December 29, 1977

Subject: Dresden Station Units 2 and 3
Fire Protection
NRC Docket Nos. 50-237 and 50-249

Attached are responses to Staff question Nos. 4, 7, 12, and 25 for Dresden Station Units 2 and 3, in addition to a clarification to PF 15 which was previously submitted.

DRESDEN 2&3
 FIGURE 2.1-10

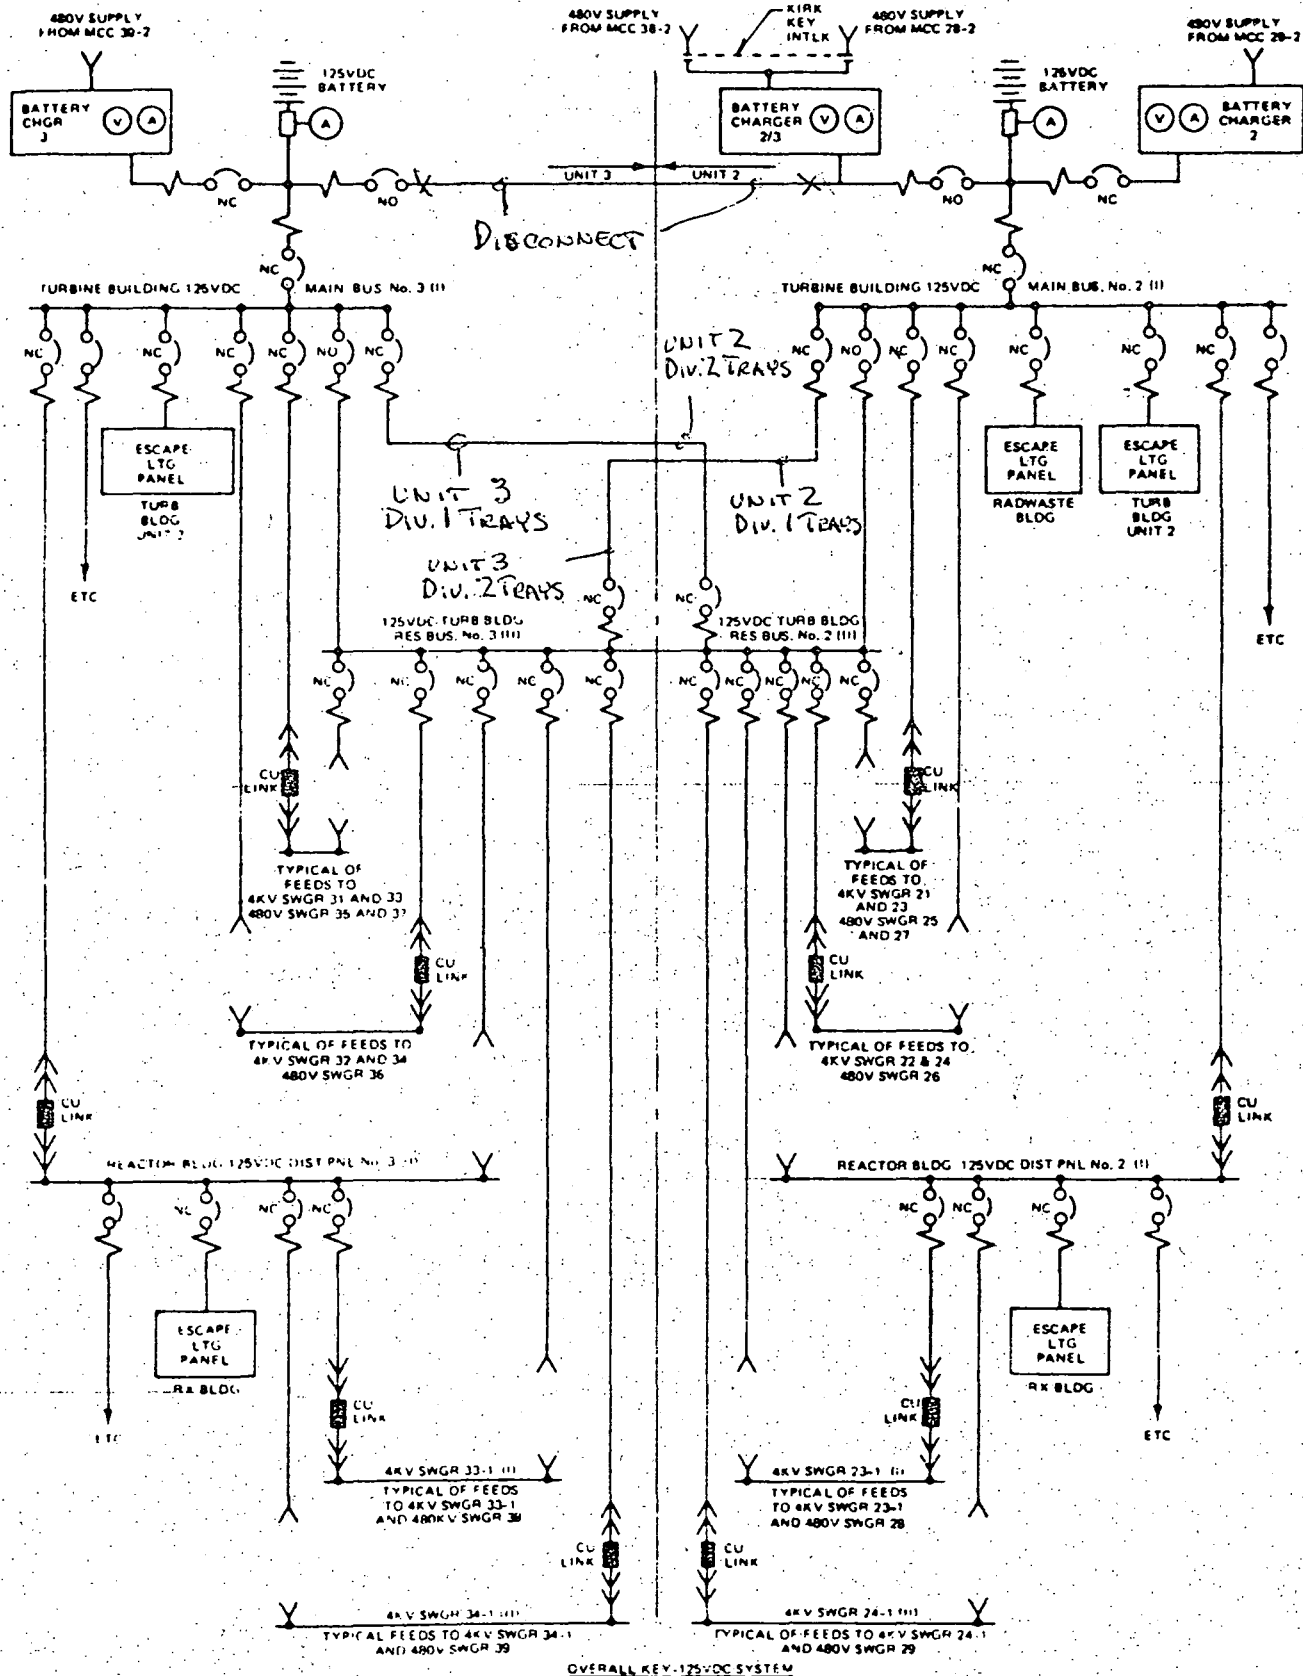
The source of dc control power for Division 1 in each unit is that unit's battery. The source of dc control power for Division 2 in each unit is the other unit's battery. In areas where Division 1 or 2 cables are not separated on a unit basis, cables could coexist which derive dc control power from both batteries. Provide an analysis that demonstrates that redundant safe shutdown systems could not be lost due to fire-related damage in either Division 1 or where dc control cables are not separated on a unit basis. For this analysis credit should not be taken for an isolation device actuated only by fault current and it should be assumed that fire-related damage to cables for control circuits could result in the advertent operation, close or trip, of any associated circuit breaker.

The interconnecting cable between units which connect Unit 2 Main DC Bus 2 (Unit 2 cable separation Division 1) to the Unit 3 Reserve DC Bus 3 (Unit 3 cable separation Division 2) is routed in Unit 2 Division 1 trays to the wall separating Unit 2 and Unit 3. On the Unit 3 side of this wall the cables are routed in Unit 3 Division 2 trays from the wall to the Unit 3 Reserve Bus 3. See Figure 2.1-10 attached.

Inspection has proven that routing of the cable connecting Unit 3 Main DC Bus 3 (Unit 3 cable separation Division 1) to Unit 2 Reserve DC Bus 2 (Unit 2 cable separation Division 2) is not correct. The cable routing from Unit 3 Main Bus 3 is in Unit 3 Division 2 trays up to the wall between Units 2 and 3. The portion of cable from the wall to the Unit 2 Reserve Bus 2 is routed in Unit 2 Division 1 trays. This cable will be rerouted so that the cable from Unit 3 Main DC Bus 3 to the wall between Units 2 and 3 is in Unit 3 Division 1 trays. The routing from the Units 2 and 3 wall to the Unit 2 Reserve DC Bus 2 will be rerouted in Unit 2 Division 2 trays. See Figure 2.1-10. When this cable is rerouted, the interconnecting cables will be separated properly on a divisional basis.

The cable which connects Battery Charger 2/3, which is located in the Unit 2 battery room, to the Unit 3 battery is routed incorrectly from a separation standpoint. This cable will be disconnected and battery charger 2/3 will become a spare charger dedicated to Unit 2. A spare charger will be purchased for use in charging the Unit 3 battery. See Figure 2.1-10.

The result of a fire and/or fire related damage in tray sections common to both the reserve and the main feeds of the services listed above could be loss of both 125 volt systems (Unit 2 and 3) and therefore loss of both Division I and Division II dc systems. See Figure 2.1-10.

Steps are in progress to correct this condition by leaving the CU Links out at the various loads as shown in the Figure 2.1-10. In addition the source circuit breakers at the Main or Reserve Busses will be opened. This will deenergize the cables between the sources and the loads such that a fire at one of the loads would not affect both DC division since the cable from the second division at any load location is not connected to the a source. Administrative control will prevent closing of either the circuit breaker or the links unless the other supply is disconnected both at the circuit breaker (source) and the link (load).
